**Request for Additional Information No. 361, Supplement 6**

**U.S. EPR Standard Design Certification**

**SRP Section: 09.02.02 - Reactor Auxiliary Cooling Water Systems**

**Question 09.02.02-95:****Follow-up to RAI 174, Question 09.02.02-53**

Figure 2.7.2-1—Safety Chilled Water System Functional Arrangement  
Sheet 1 of 4

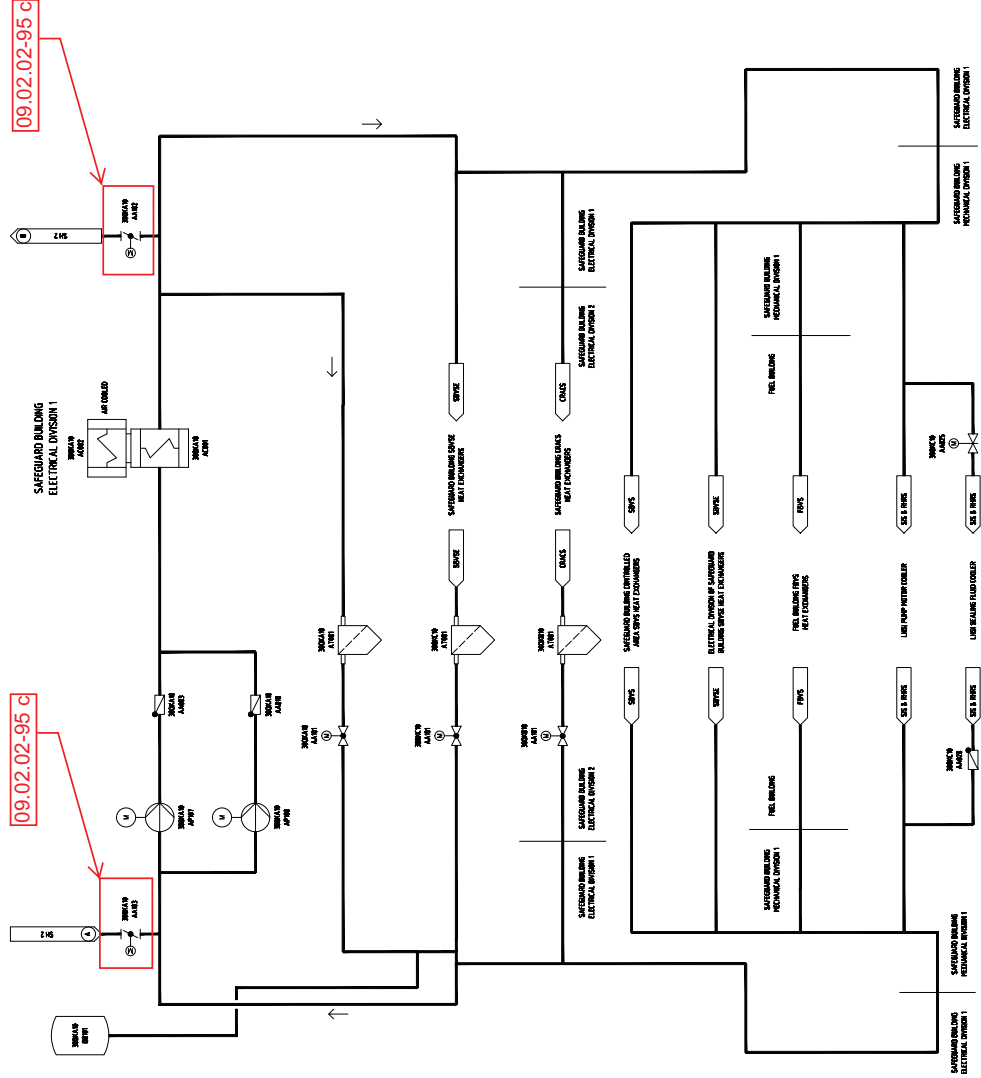
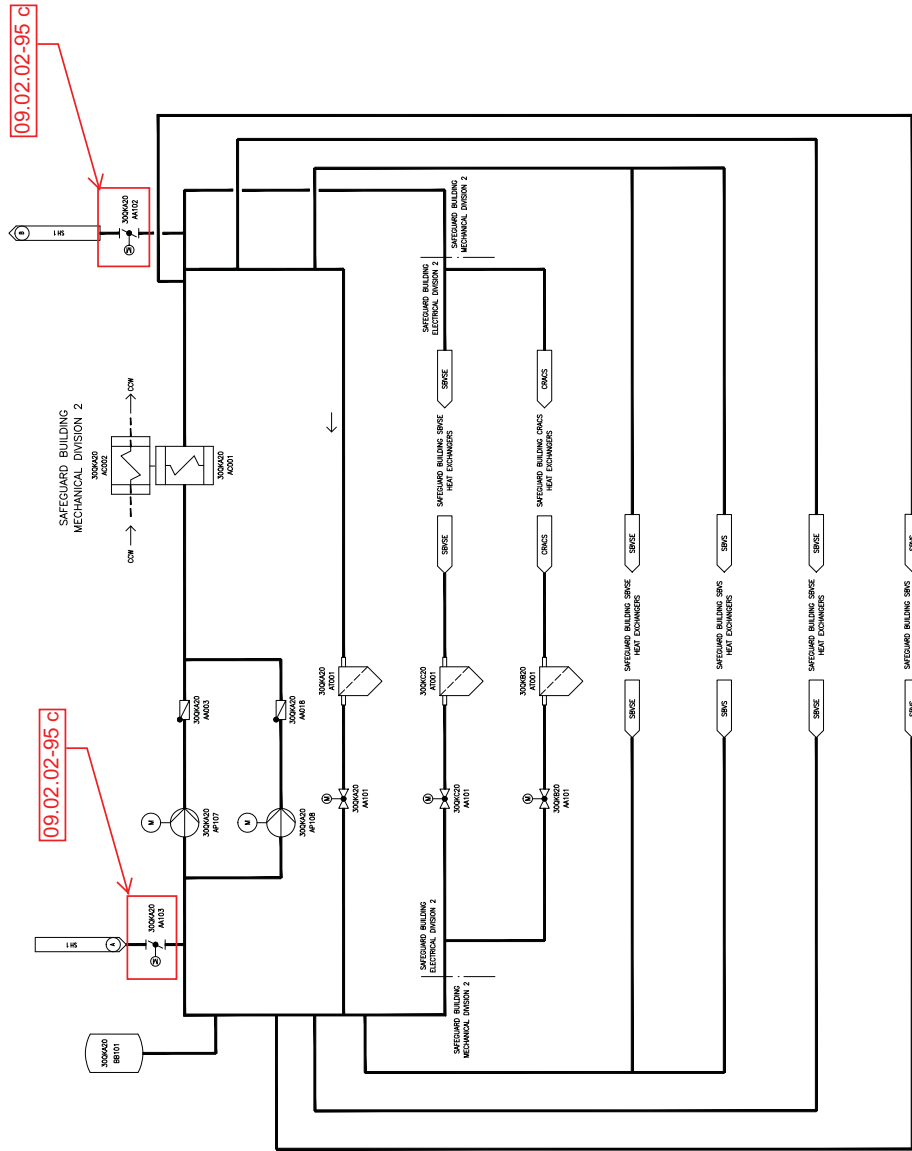
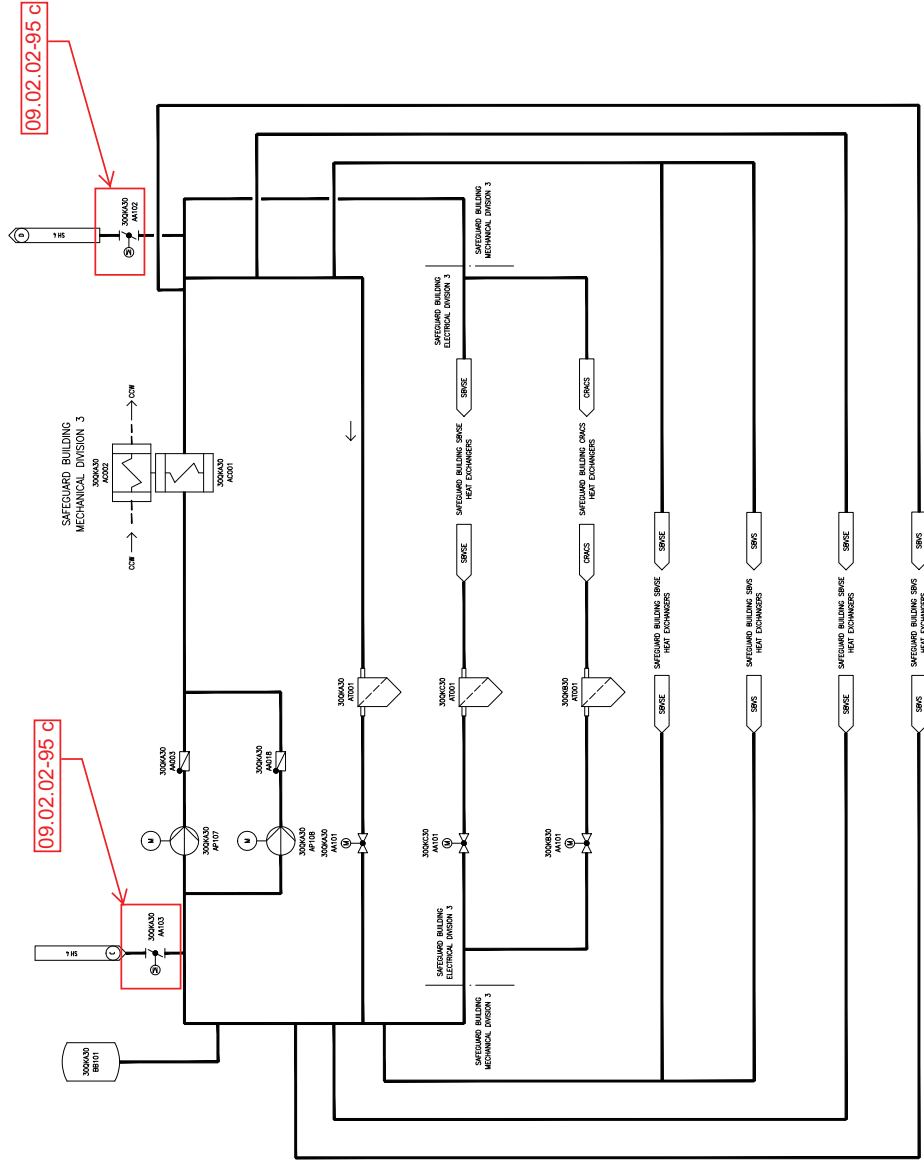
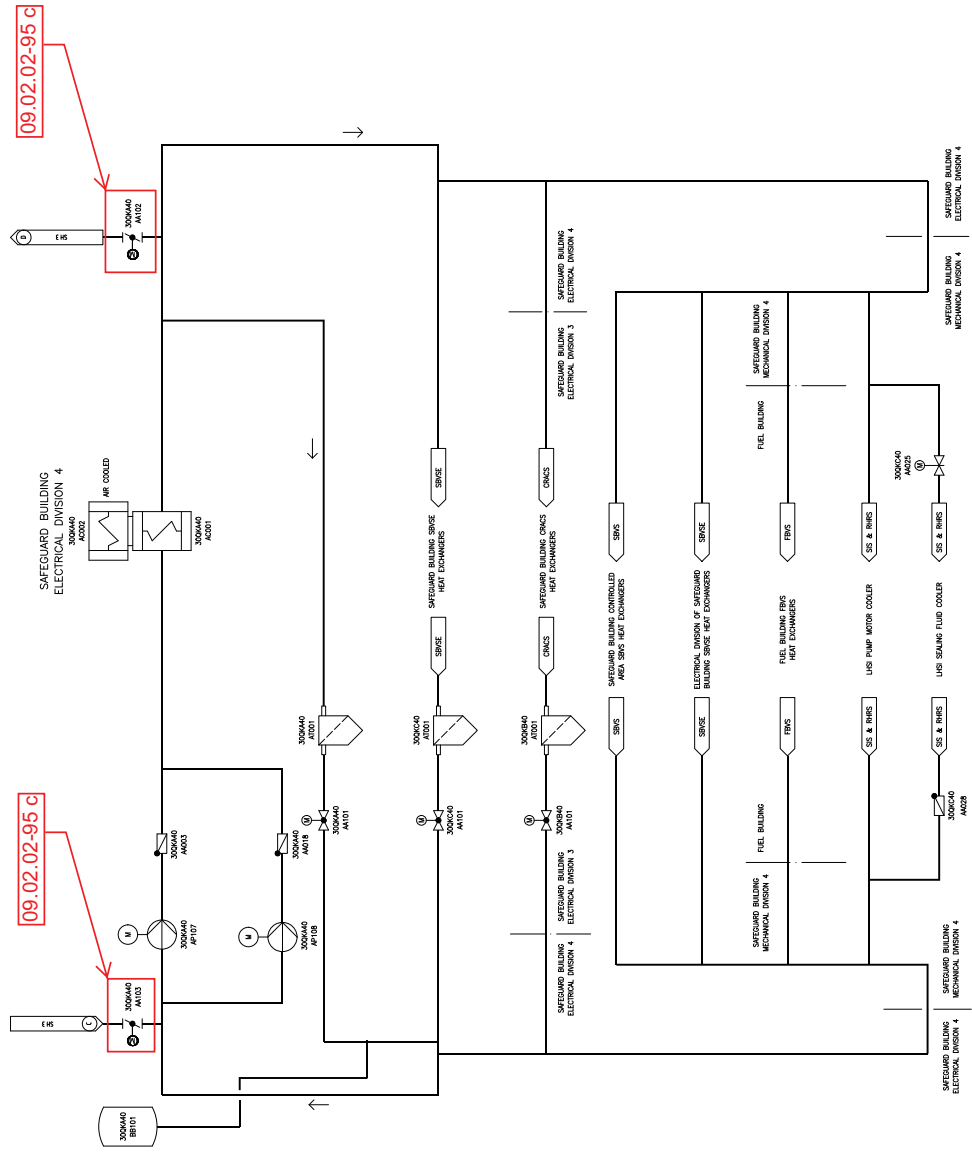
Standard Review Plan (SRP) Section 9.2.2, which is being utilized as guidance for the review of the safety chilled water system (SCWS), specifies in Section III confirmation of the overall arrangement of the component cooling system (CCWS) in the Final Safety Analysis Report (FSAR). Based on the staff's review of the applicant's response to RAI 174, Question 9.2.2-53, Supplement 5 and information provided in the associated markup of the Final Safety Analysis Report (FSAR), Section 9.2.8, "Safety Chilled Water System" the staff found a significant design change to the system. The safety chilled water system (SCWS) design now utilizes "cross-ties" between Trains 1 and 2 and between Trains 3 and 4, instead of the independent four-train system structure utilized in the original design.

- a. The staff noted that Tier 1 Table 2.7.2-2, "Safety Chilled Water System Equipment I&C and Electrical Design," identifies normal and alternate power supplies for the motor-operated SCWS cross-tie valves, but the valve power supplies are not described anywhere in the proposed Tier 2 FSAR sections provided in the response.
- b. Provide a description of these power supplies in the Tier 2 portion of the FSAR.
- c. Update FSAR Table 3.9.6-2, "In-service Valve Testing Program Requirements" to include the motor-operated cross-tie valves.
- d. Add the SCWS flow direction arrows to the Figure 9.2.8-1 (Sheets 1 through 4), "Safety Chilled Water Diagram," to confirm the directional flows in various sections of pipe under both independent and cross-tie alignments.

- b) Refer to the response to Part a.
- c) U.S. EPR FSAR Tier 2, Table 3.9.6-2—Inservice Valve Testing Program Requirements will be revised to include the motor-operated cross-tie valves. Additional changes to this table will include changing several large diameter valves from plug valves to butterfly valves and adding a number of manually operated valves. Also, a check valve will be added to each SCWS train demineralized water source connection to prevent backflow and/or contamination of the demineralized water system.
- d) Refer to the Response to RAI 174, Supplement 5, Question 09.02.02-53. Flow direction arrows will be added to applicable sheets of U.S. EPR FSAR Tier 1, Figure 2.7.2-1—Safety Chilled Water System Functional Arrangement, and U.S. EPR FSAR Tier 2, Figure 9.2.8-1—Safety Chilled Water System Diagram.

The sheet-to-sheet continuation arrows provide an indication of flow direction. On Sheets 1 through 4, the supply side is on the right and the return side is on the left. For cross-tie operation, flow can be in either direction in the cross-tie lines depending on which SCWS train is in operation. For example, if SCWS Train 1 is the operating train in divisional pair 1 & 2, starting on Sheet 1, approximately half the total flow is through Train 1 cross-tie supply valve 30QKA10AA102 (continuation to sheet 2), then through Train 2 cross-tie supply valve 30QKA20AA102 to Division 2 user heat exchangers. Similarly, on the return side, starting on Sheet 2, return flow is from the Division 2 user heat exchangers through the Train 2 cross-tie return valve 30QKA20AA103 (continuation to sheet 1), then through Train 1 cross-tie return valve 30QKA10AA103 to the suction side of the Train 1 pumps. As shown on Sheet 1, on the supply side, the other approximate half of the total flow goes to the Division 1 user heat exchangers and returns to the suction side of the Train 1 pumps.

U.S. EPR FSAR Tier 1, Figure 2.7.2-1, and U.S. EPR FSAR Tier 2, Sections 9.2.8.3.2 and 9.2.8.4, Table 3.9.6-2, and Figure 9.2.8-1 will be revised as described in the response and indicated on the enclosed markup.
